Network Administration Approval Form	Ref: TAG meeting

This is a request to install appropriate speed control signage on 16B Capricorn Highway to enforce speed limits that are compatible with the speed environment. Please refer attached Sketch 01.

Installation and/or Removal of Regulatory Traffic Signs/Devices

Section/Location: Township of Comet. 118.0km - 120.0km

PI AN

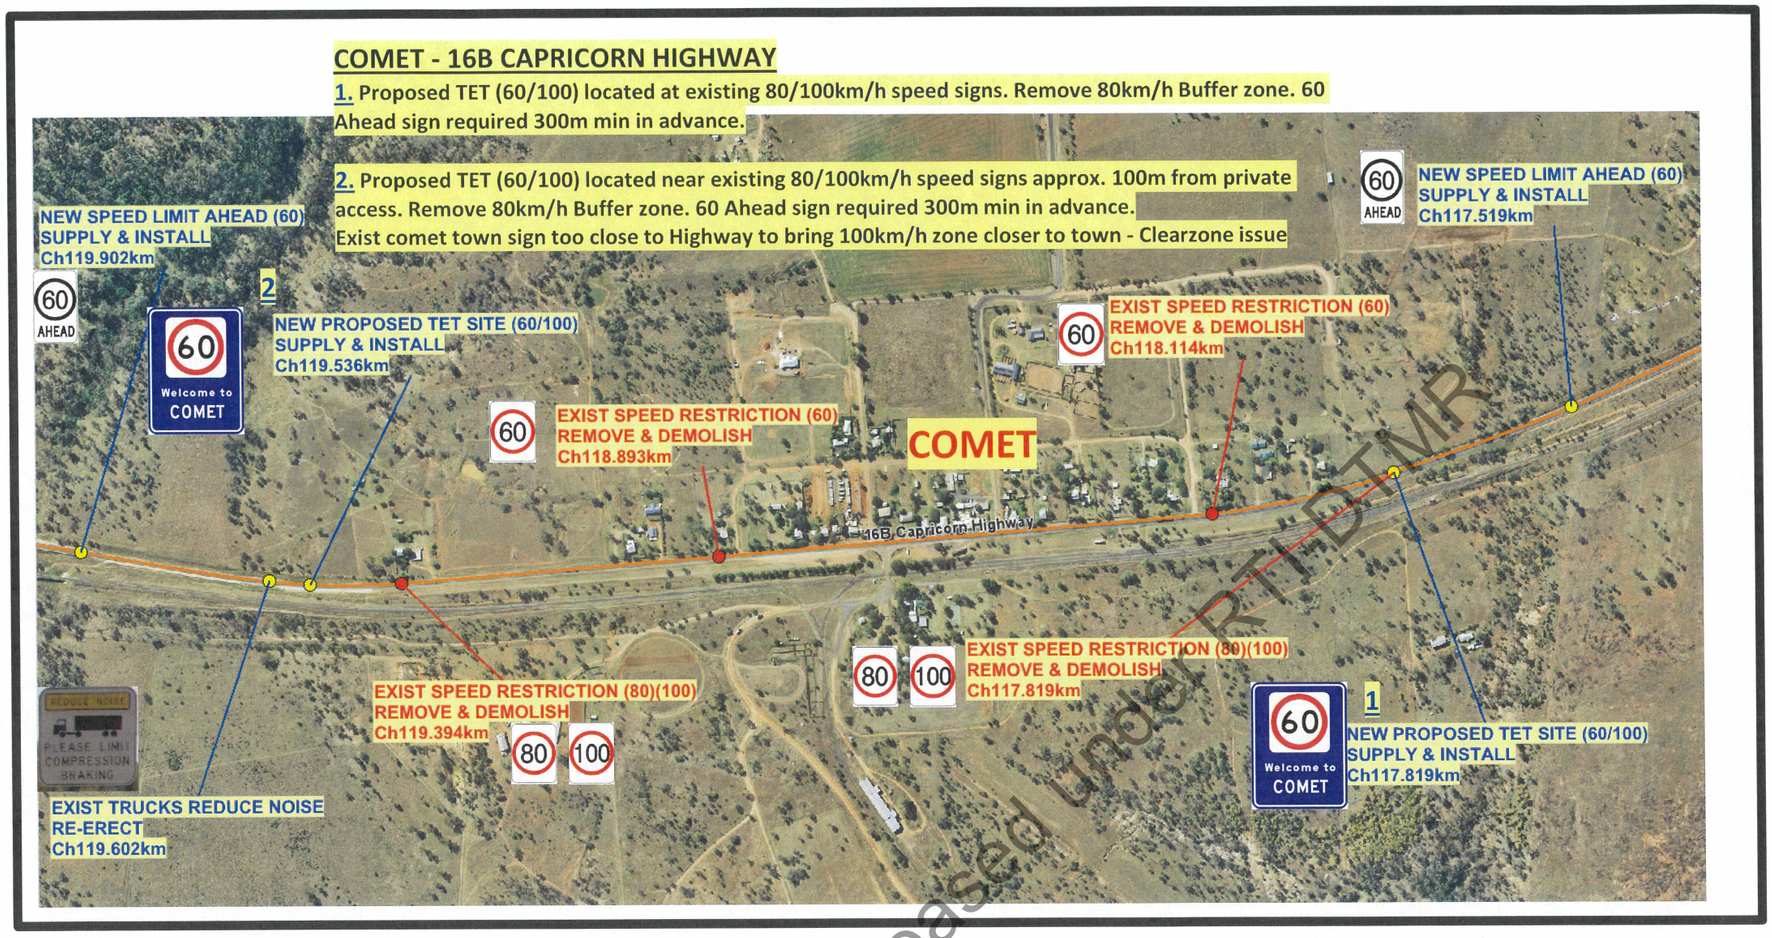
- Remove existing 80km/h speed restriction sign panels and replace with 60km/h speed restriction sign (R4-1C) panels located at approximate chainage 117.80km (LHS and RHS – approximately 340m east of Capricorn Highway and Cable Street (RHS) intersection) on the western approach to Comet. Refer Sketch 01.

- Install 60km/h Speed Limit AHEAD sign (G9-79B) on both sides (LHS and RHS) of Capricorn Highway at approximately 300m in advance of the above new 60km/h speed restriction sign (R4-1C) on the western approach to Comet. Approximate chainage is 117.50km. Refer Sketch 01.

- Remove existing 80km/h speed restriction sign panels and replace with 60km/h speed restriction sign (R4-1C) panels located at approximate chainage 119.40km (LHS and RHS – approximately 550m west of Capricorn Highway and McPherson Street (RHS) intersection) on the eastern approach to Comet. Refer Sketch 01.

- Install 60km/h Speed Limit AHEAD sign (G9-79B) on both sides (LHS and RHS) of Capricorn Highway at approximately 300m in advance of the above new 60km/h speed restriction sign (R4-1C). Approximate chainage is 119.70km. Refer Sketch 01.
